Access Compliance Report

Public Rights-of-Way

Intersection ID: 15175	Main Street: SOUTH_BV	Cross Street: POINDEXTER_DR	Location: W
ADA ID: C2486B6FDF95	Ramp Type: Perp	Initial Pass/Fail: Fail	Overall Compliance: No
			Severity Score: 10

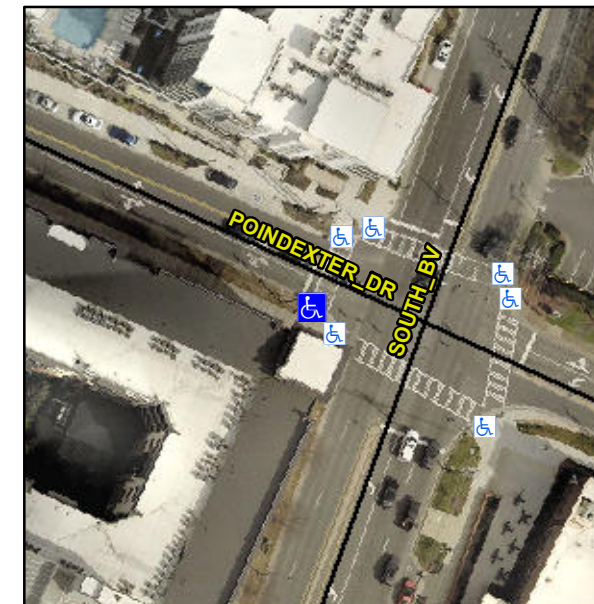
Not Found, R304.5.1, R304.5.3

Compliance	Description	Data	Compliance	Description	Data
N/A	Ramp Length (in)	96.0	Yes	Ramp Slope (%)	5.8
No	Ramp Width (in)	46.5	No	Ramp XSlope (%)	3.2
N/A	Flare Type LT	N/A	N/A	Flare Type RT	N/A
N/A	Flare Slope LT (%)	N/A	N/A	Flare Slope RT (%)	N/A
N/A	Flare Traversable LT?	N/A	N/A	Flare Traversable RT?	N/A
N/A	Landing Length (in)	N/A	N/A	DWS Provided?	N/A
N/A	Landing Width (in)	N/A	N/A	DWS Contrast?	N/A
N/A	Landing Slope (%)	N/A	N/A	DWS Length (in)	N/A
N/A	Landing X Slope (%)	N/A	N/A	DWS Full Width?	N/A
N/A	Landing Curb? (Y/N)	N/A	N/A	DWS Offset (in)	N/A
N/A	Shared Landing?	N/A			
N/A	Gutter Ponding?	N/A	N/A	Gutter Slope (%)	N/A
N/A	Gutter Lip Ht (in)	N/A	N/A	Gutter X Slope (%)	N/A
N/A	Painted X Walk1?	Yes	N/A	Painted X Walk2?	N/A
	X Walk 1 Direction	To NE		X Walk 2 Direction	N/A
N/A	X Walk 1 Width (in)	110.0	N/A	X Walk 2 Width (in)	N/A
	X Walk 1 Slope (%)	0.3		X Walk 2 Slope (%)	N/A
	X Walk 1 X Slope (%)	1.7		X Walk 2 X Slope (%)	N/A

Remove & Replace Entire Ramp.
